CHANGE ORDER #3

Project: #1232.002 - RUSHMORE PLAZA
CIVIC CENTER MULTIPURPOSE
ADDITION - BID PACKAGE 1

Change Order No.: 3 - FINAL

Elevator Shaft Grade Beam

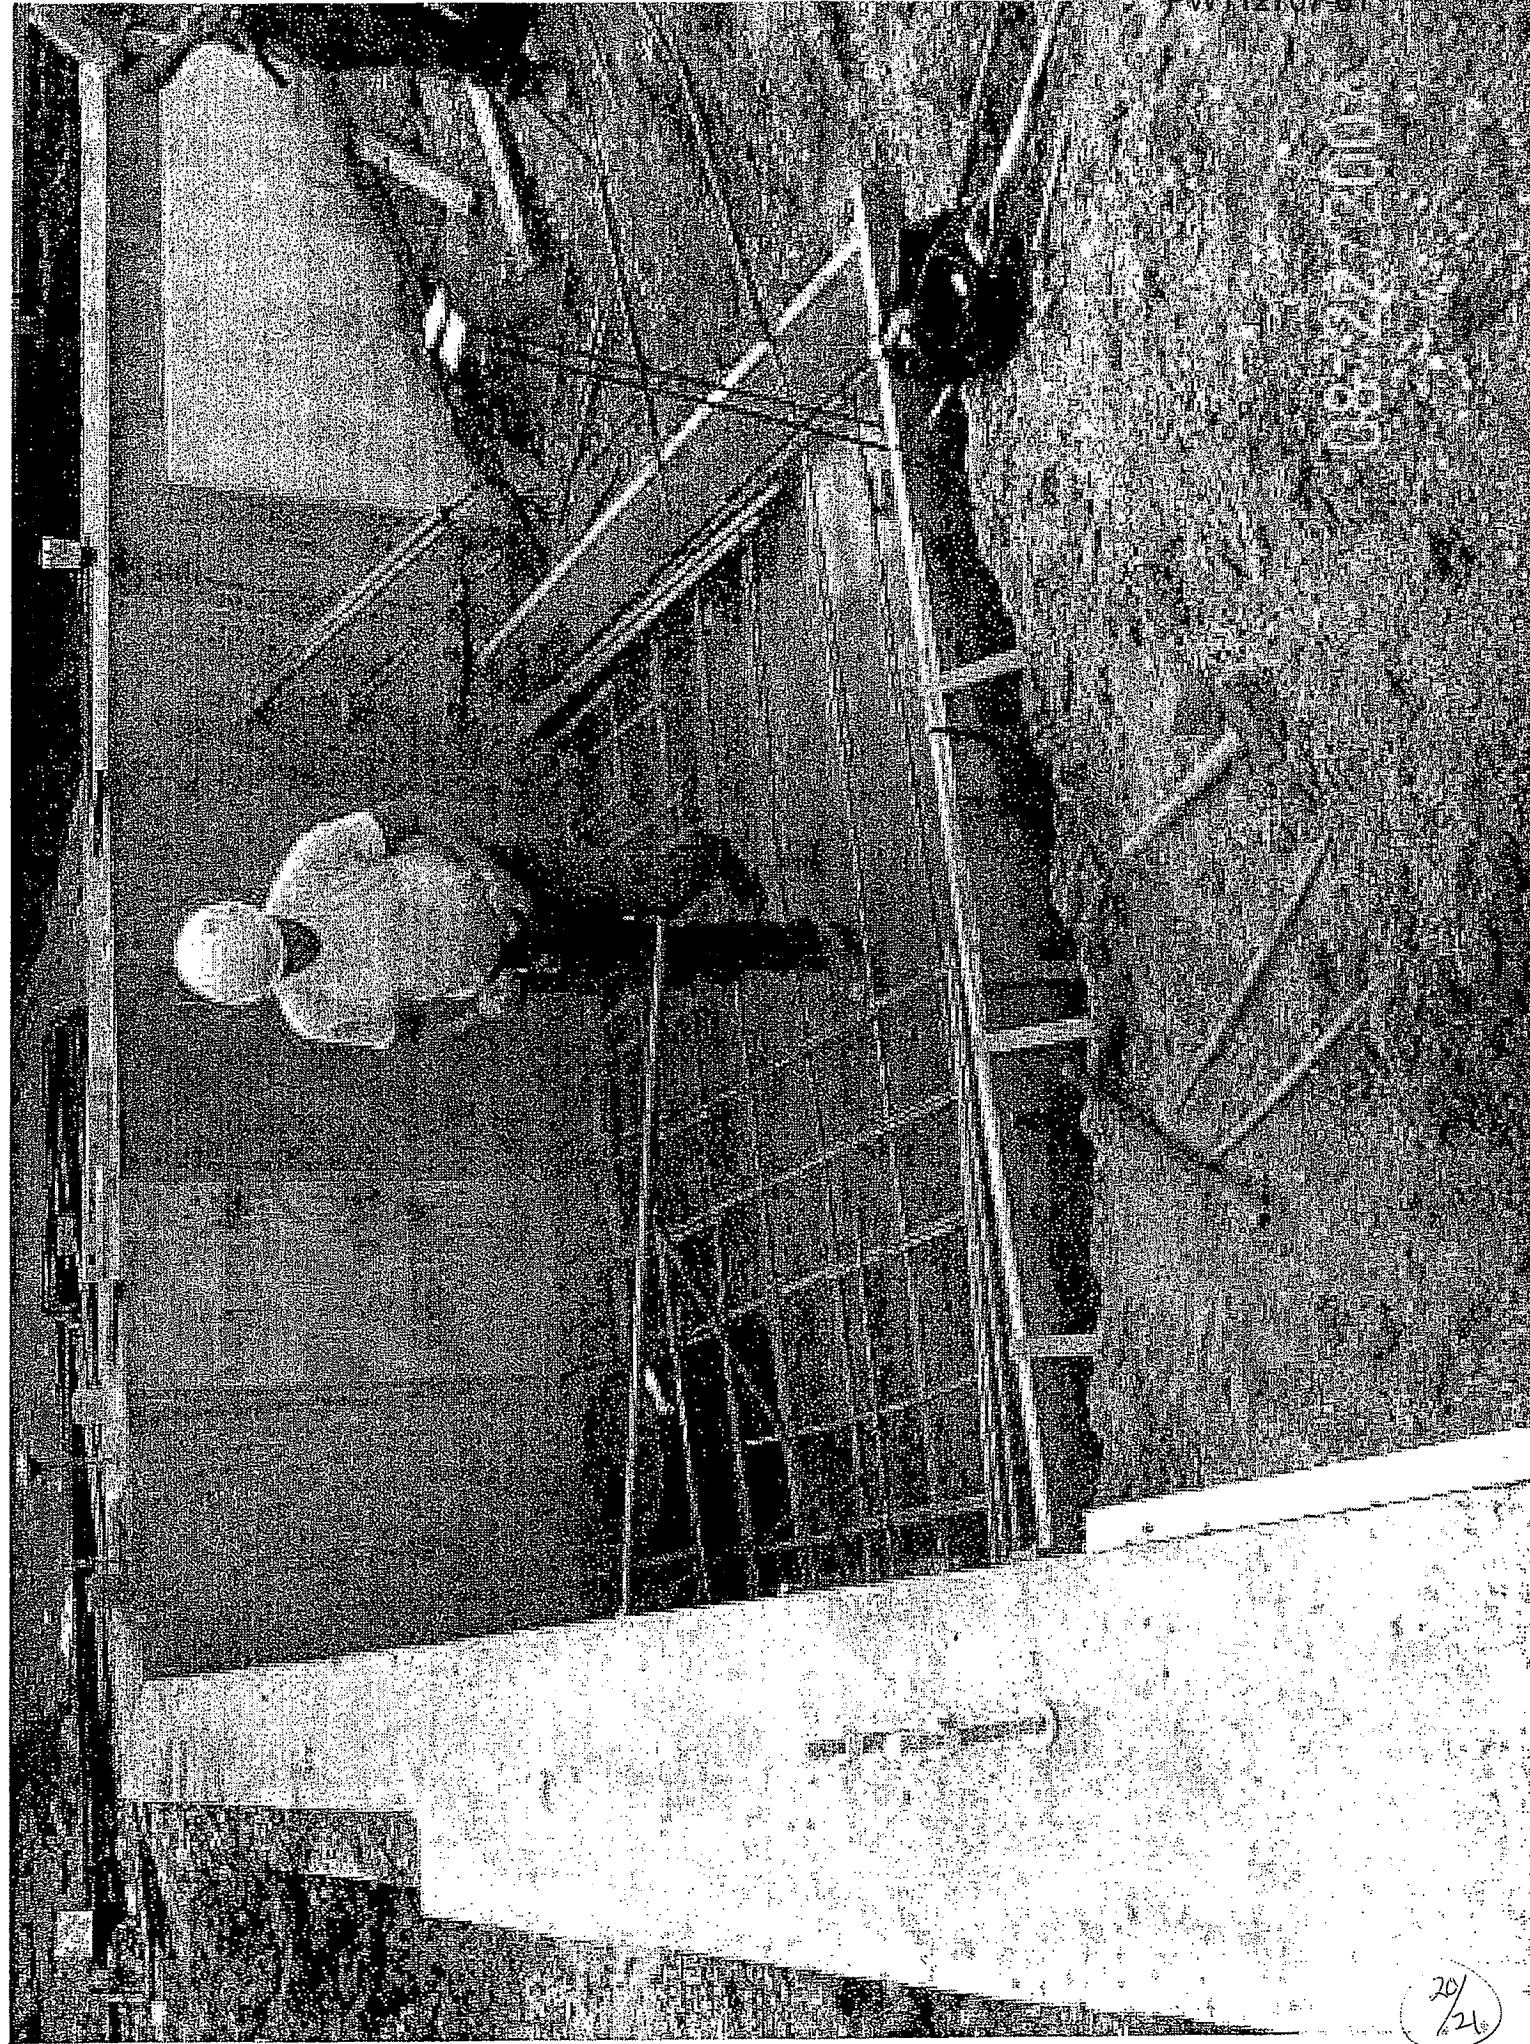
The two GB-2 grade beams that are shown on Sheet # S11.11 are shown to be existing, please advise as to how this should be handled. This appears to be part of Bid Package #1.

GB-2 is supposed to be as follows:

12"x4'-4"

(3) #8 top and bottom bars

#4 tie at 18" cc

#5 horizontal midheight bars at 18" cc each face

TITLE: Grade Beam at C.L. 21/13.5**DATE:** 6/7/2007**PROJECT:** Rushmore Plaza Civic Center**JOB:** 07093**TO:** enVision Design Inc.
822 Main Street
Rapid City, SD 57701**ATTN:** Jeff Reuppel**REQUIRED:** 6/14/2007**PHONE:** (605) 348-2648**FAX:** (605) 348-0571**QUESTION:**

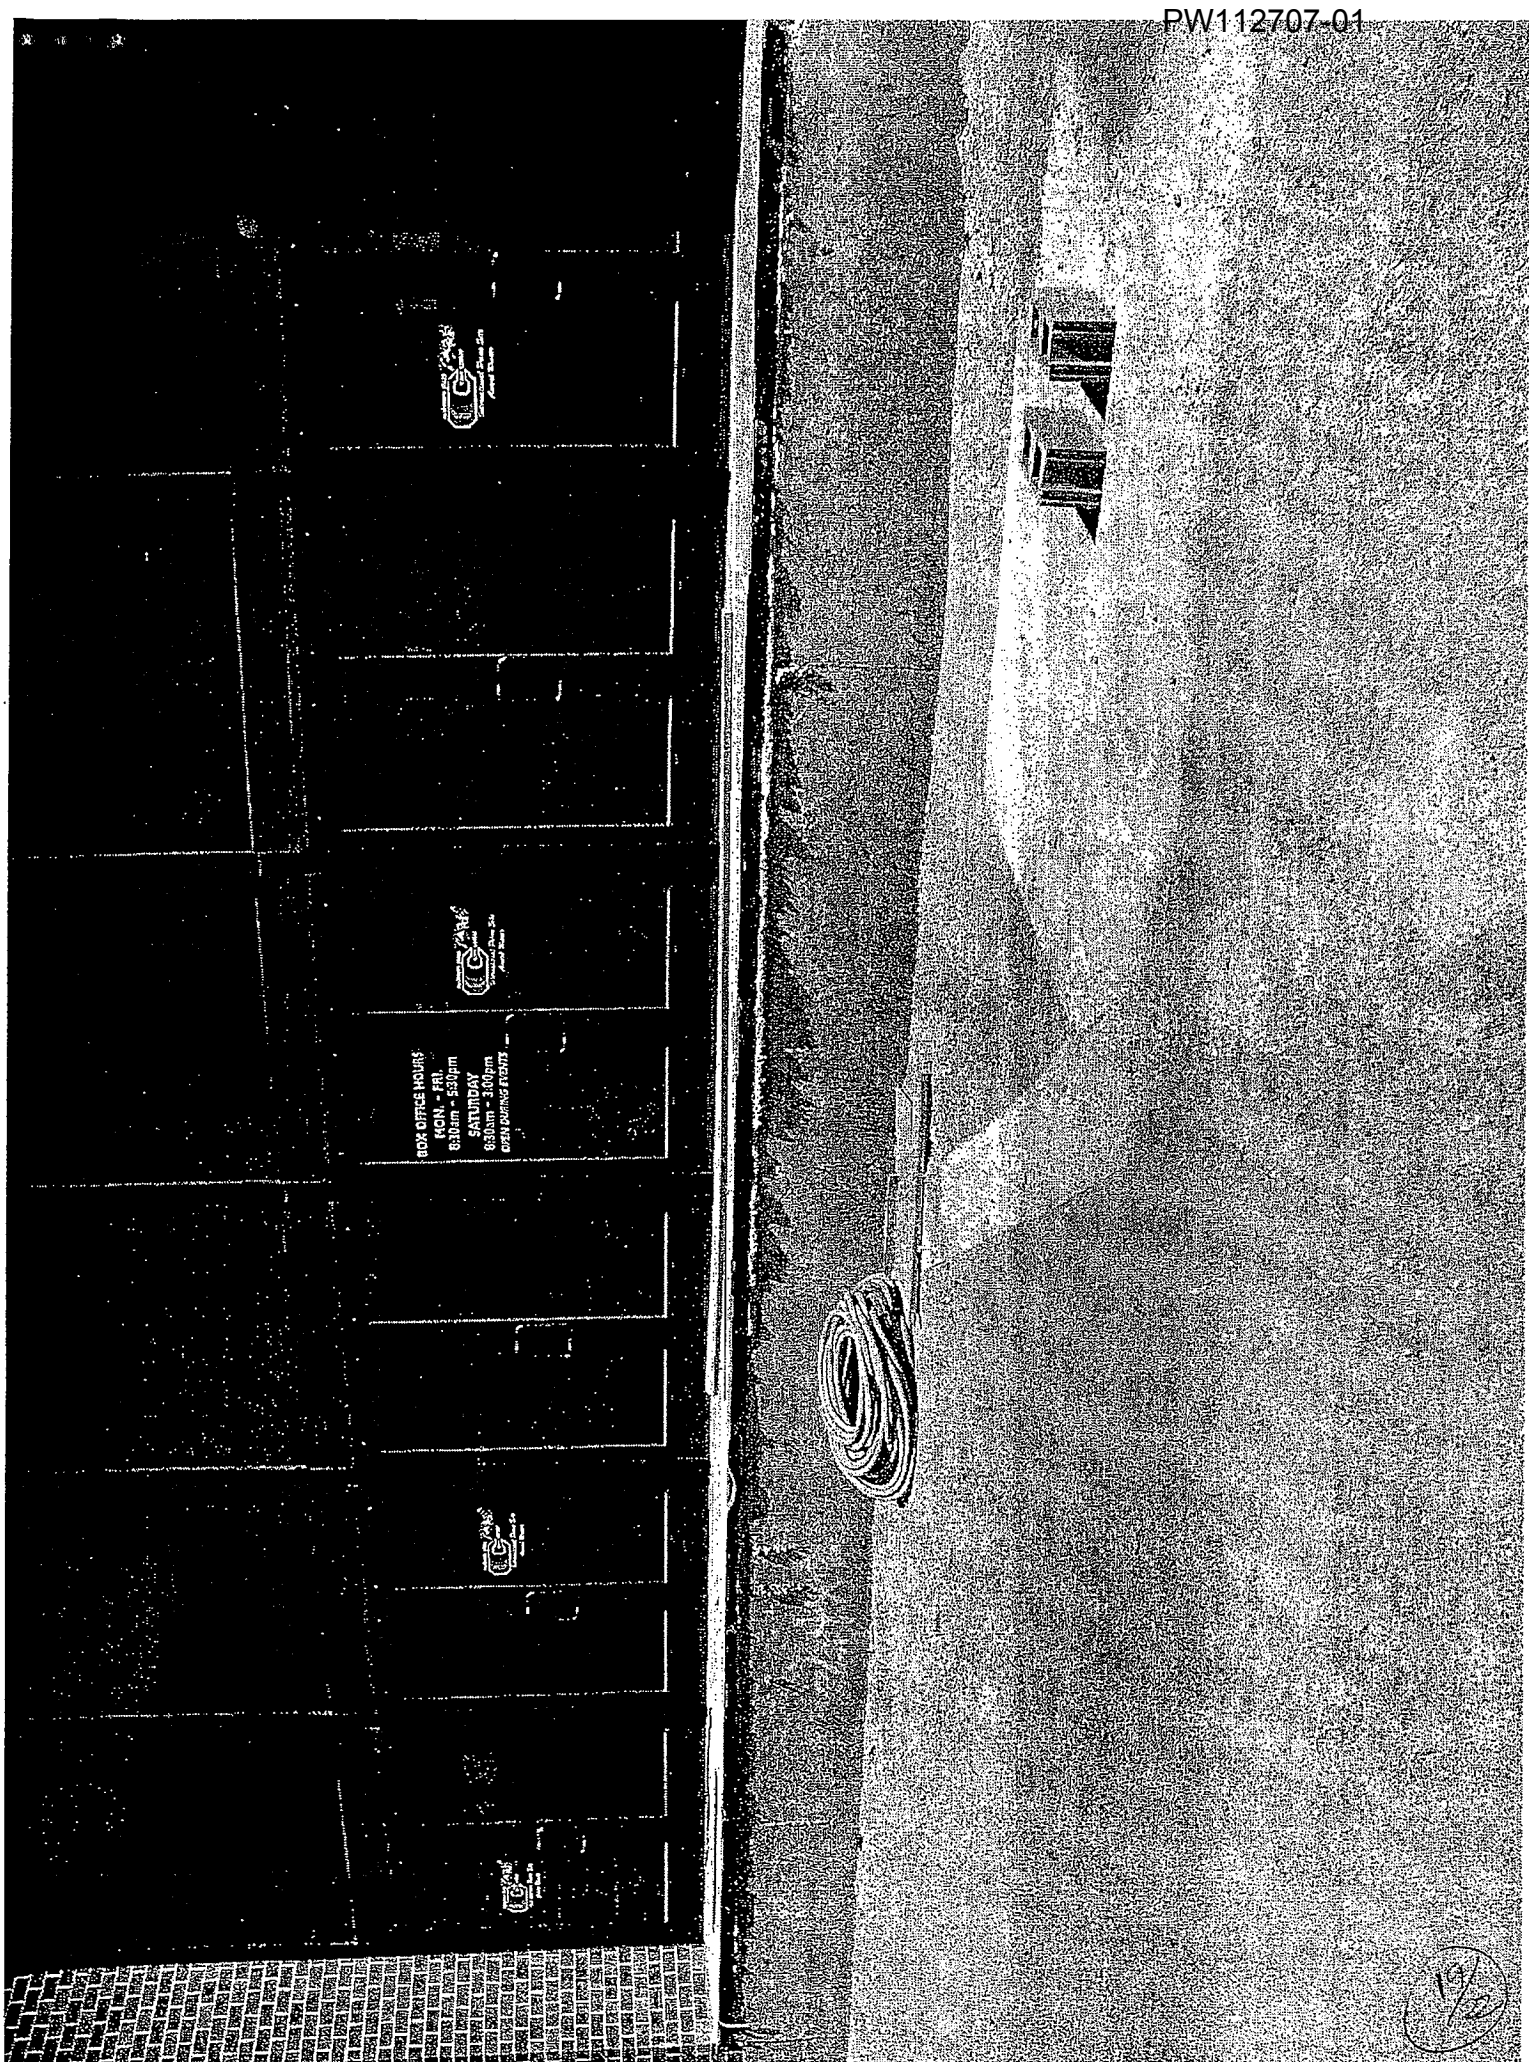
The grade beam that supports the column at col. line 21/13.5 was not poured out far enough during bid package #1. Please advise us as to what action is to be taken, with any structural sketches or information needed concerning this issue.

Top and bottom bars need to be extended in grade beam extension. Provide mechanical couplers. Roughen vertical surface of grade beam to a 1/4" amplitude. Drill and set all mid height bars into existing grade beam and set with epoxy. Minimum embedment = 8".

6 #9 Top
4 #9 Bot.
